# ADDENDUM No. 1

ITB No. 4426

## SPRINGWATER SUBDIVISION IMPROVEMENTS PROJECT PHASE II

The following changes, additions, and/or deletions shall be made to the Invitation to Bid for **ITB No. 4426 Springwater Subdivision Improvements Project – Phase II**, on which proposals will be received on/or before Thursday, April 14, 2016, by 2:00P.M.

PROJECT MANAGEMENT - PUBLIC SERVICES - CITY OF ANN ARBOR  
SPRINGWATER SUBDIVISION - PHASE II  
SAND FILTER OVERFLOW STRUCTURE DETAIL

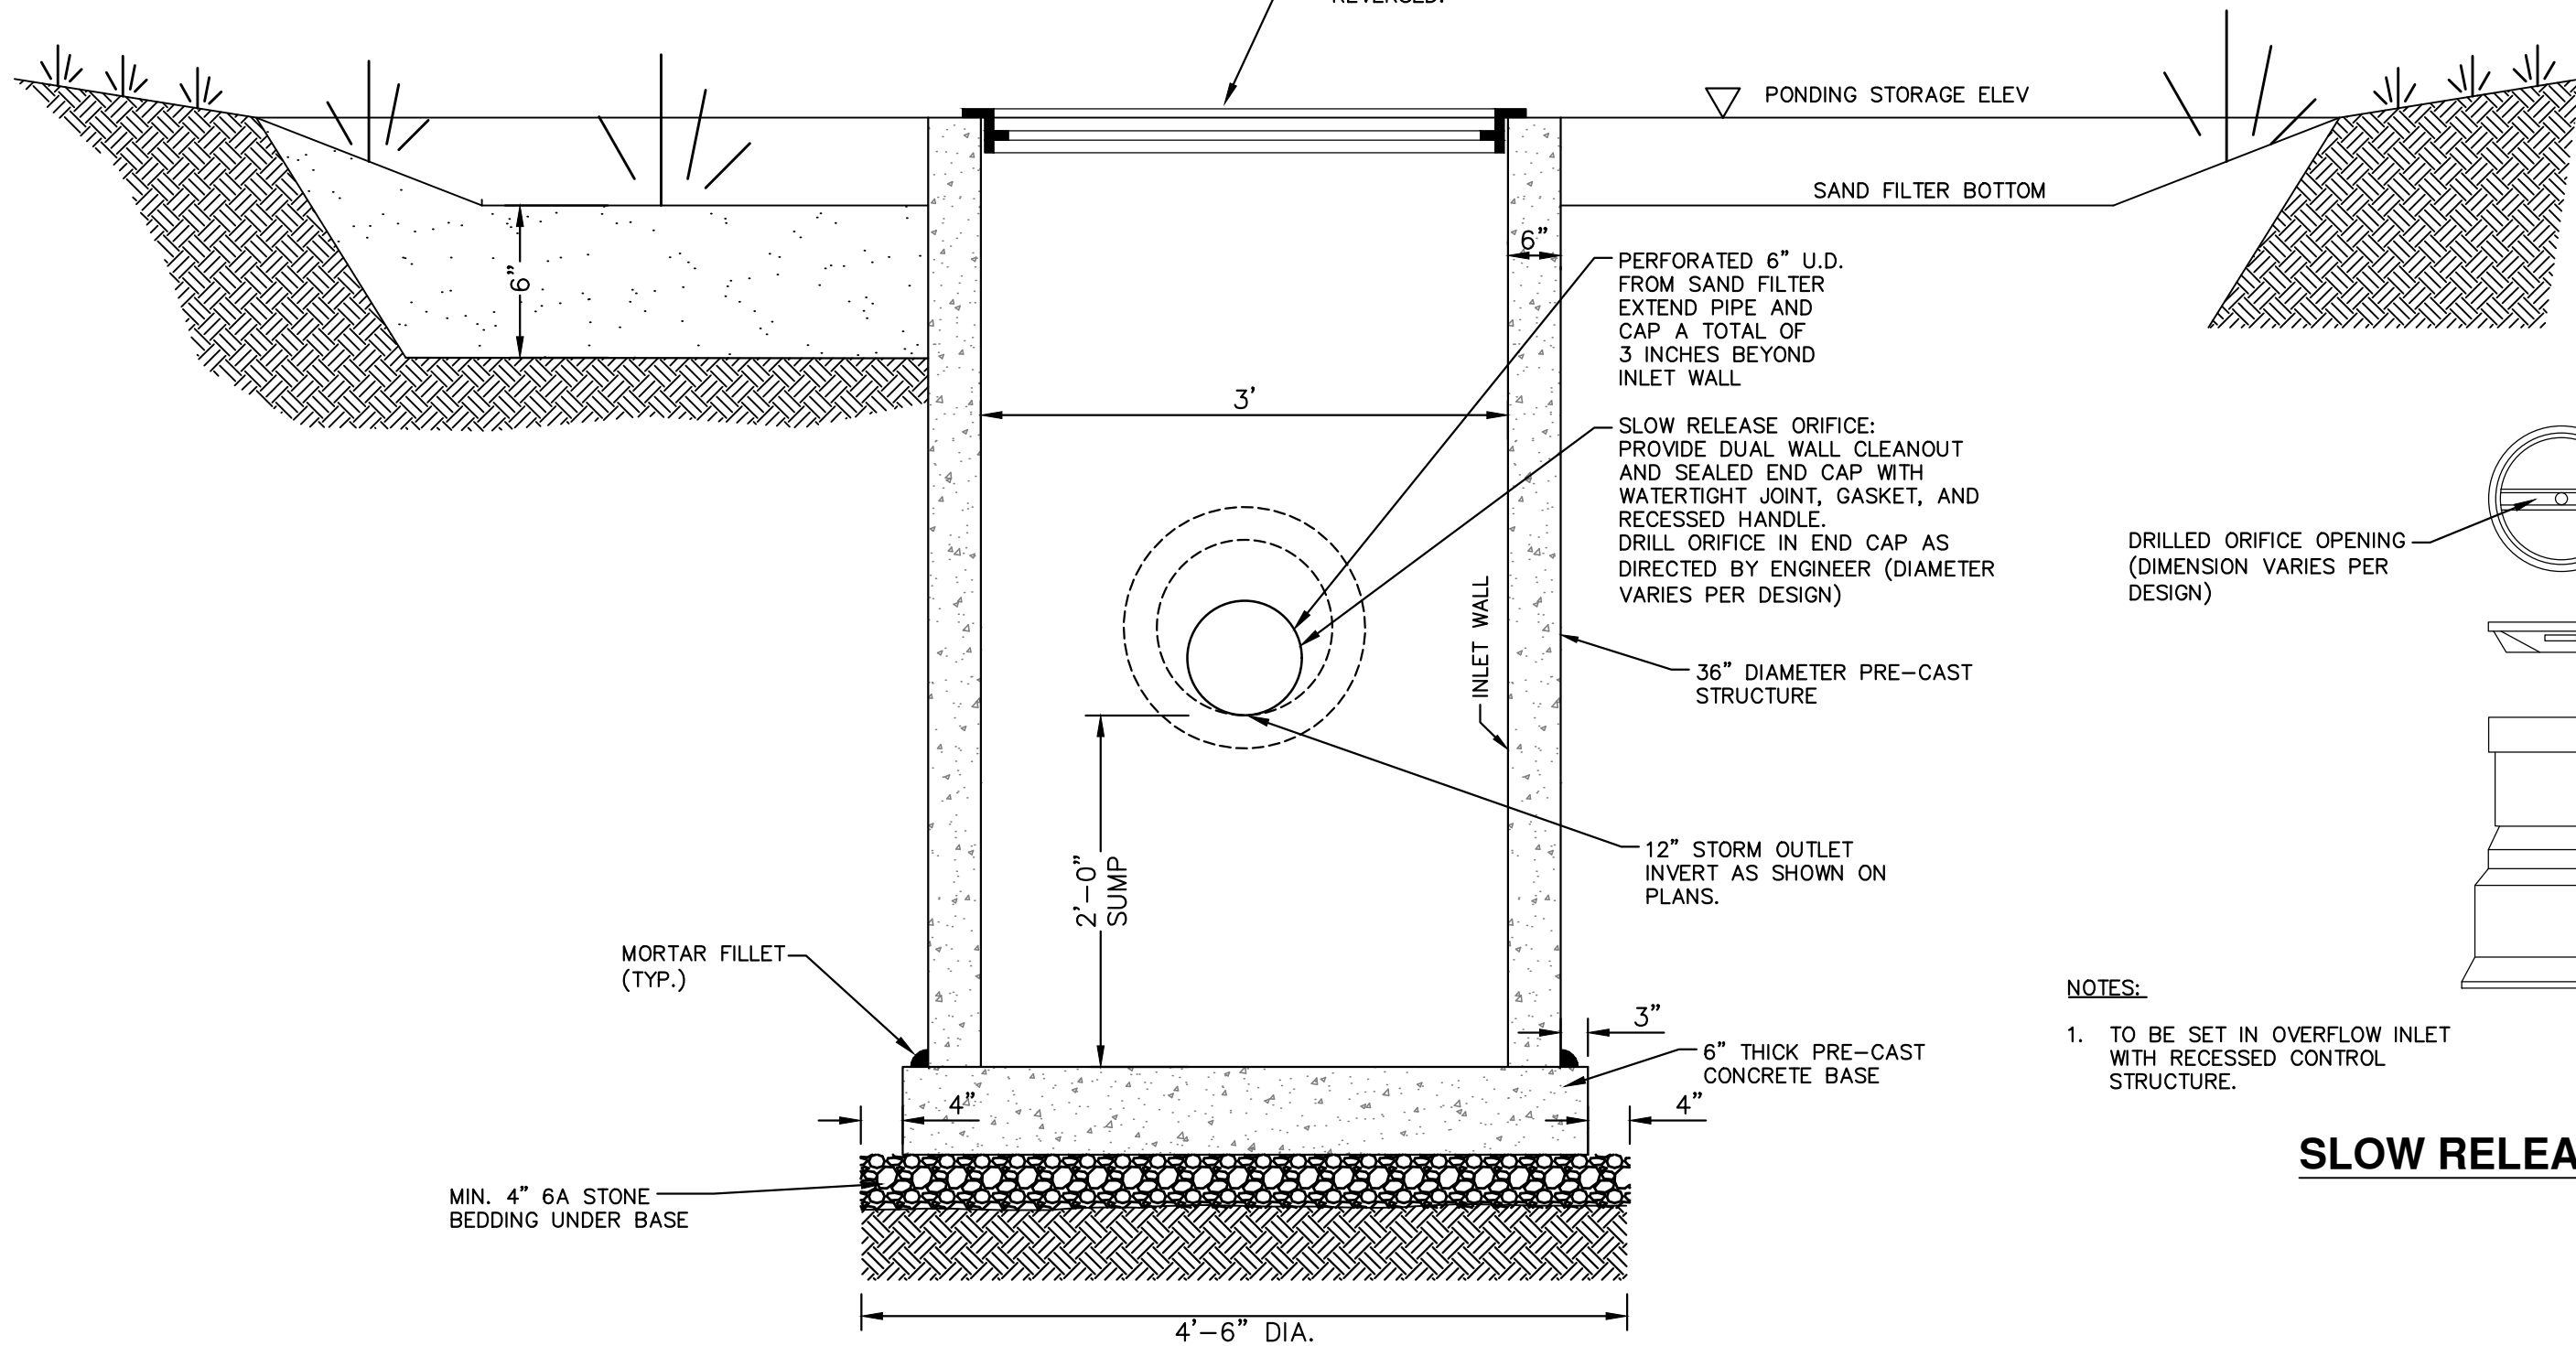
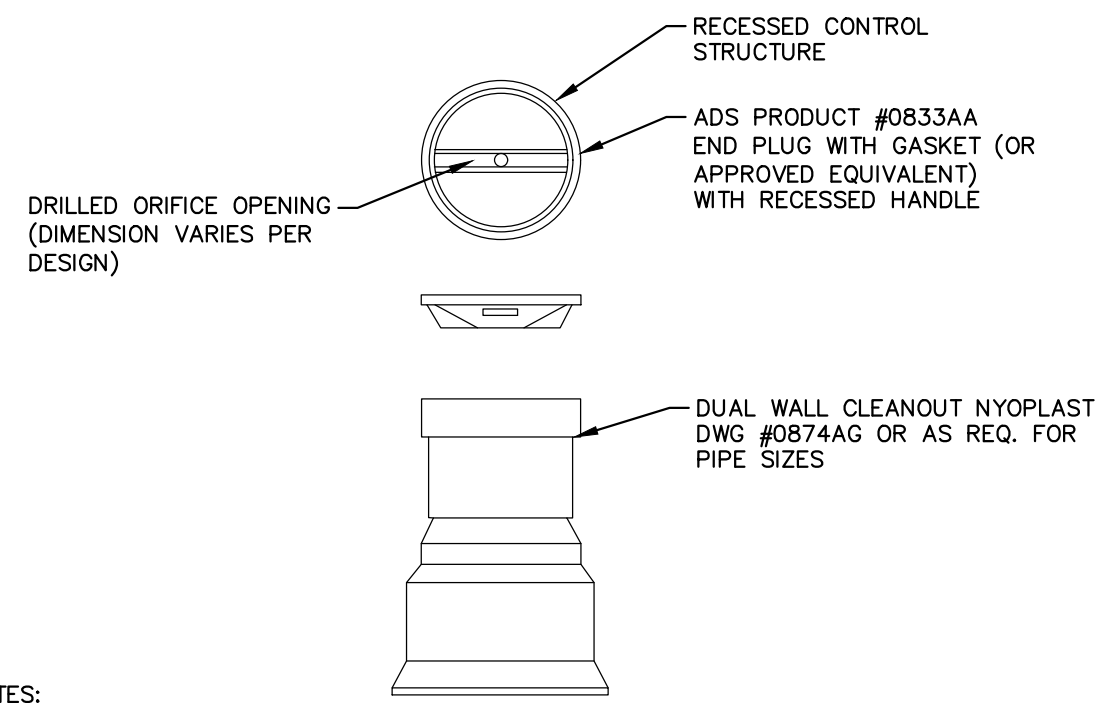
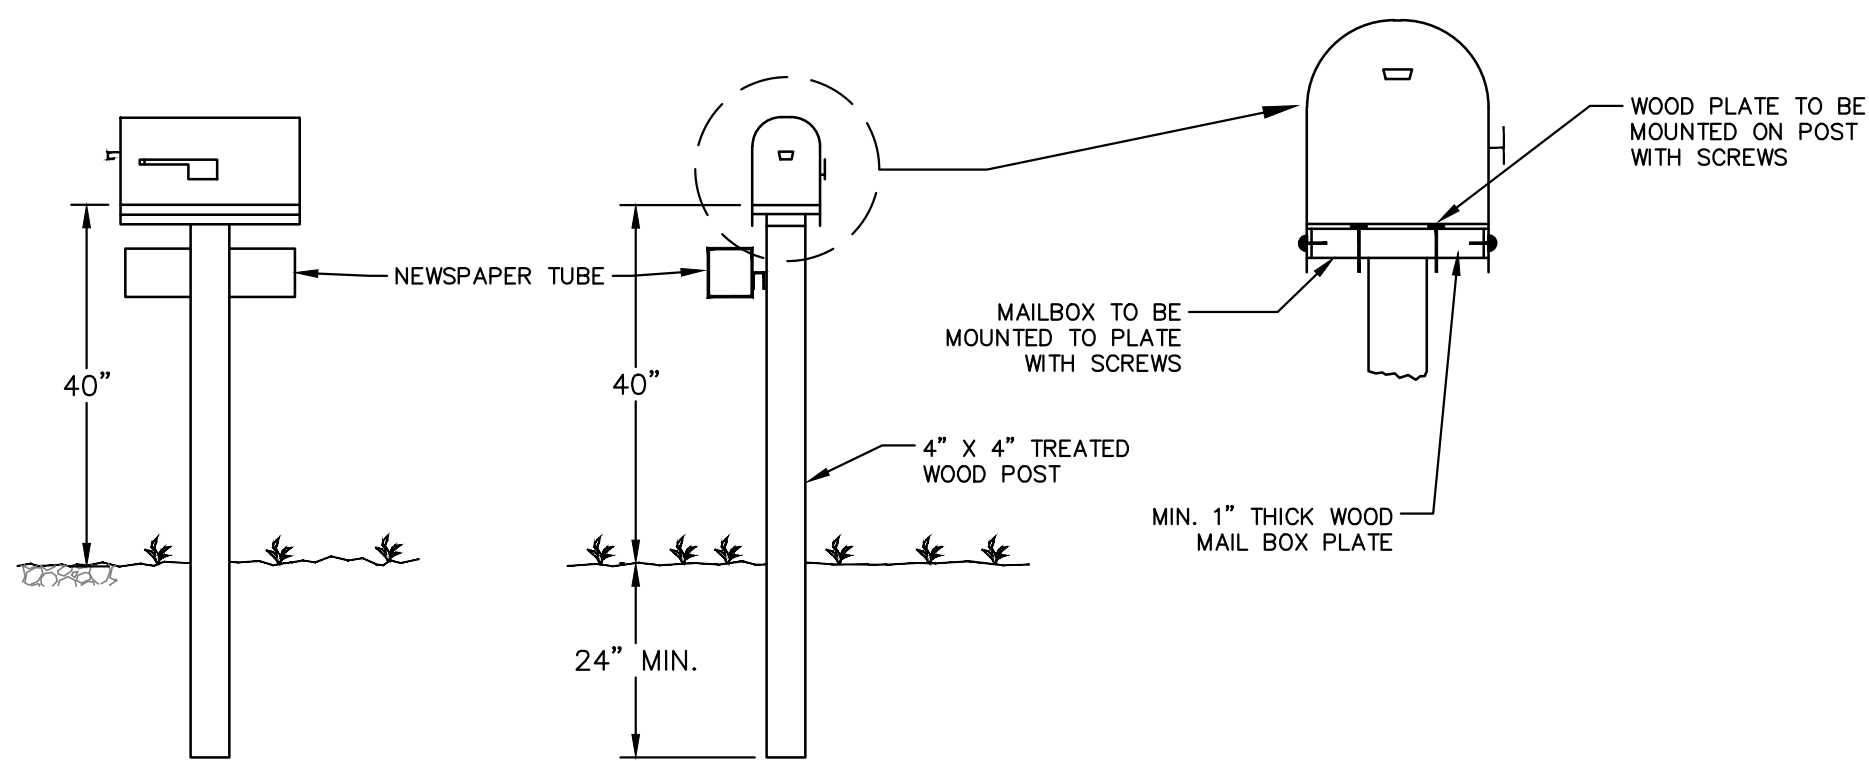
DS-36 – DS-42	The “Detailed Specification for Acceptance of HMA Mixtures” shall be deleted.
DS-79 – DS-85	These pages shall be removed and replaced by DS-79-R-1 through DS-85-R-1, which are attached below.
Plans Sheets 3, 6, 7 & 8	<p>These plan sheets shall be removed and replaced with the attached plans sheets #3, 6, 7 and 8. The significant changes to these plans sheets include the following:</p> <p>On plan sheet #3 the 12 inch sand subbase, CIP is shown to consist of MDOT Granular Material Class II, Modified.</p> <p>On plan sheet #6 the PVC membrane surrounding the sand filter was eliminated.</p> <p>On plan sheet #7 the aggregate stone barrier was eliminated at the top of the Sand Filter Overflow Structure detail.</p> <p>On plan sheets #4 &amp; #8 the aggregate backfill over the underground storage chambers is now identified as clean, washed MDOT 6A stone.</p>

- d. The PVC membrane surrounding the sand filter will be eliminated and will be reflected in Addendum #1.
- e. The aggregate stone backfill shall be eliminated at the top of the Sand Filter Overflow Structure detail and will be reflected in Addendum #1.
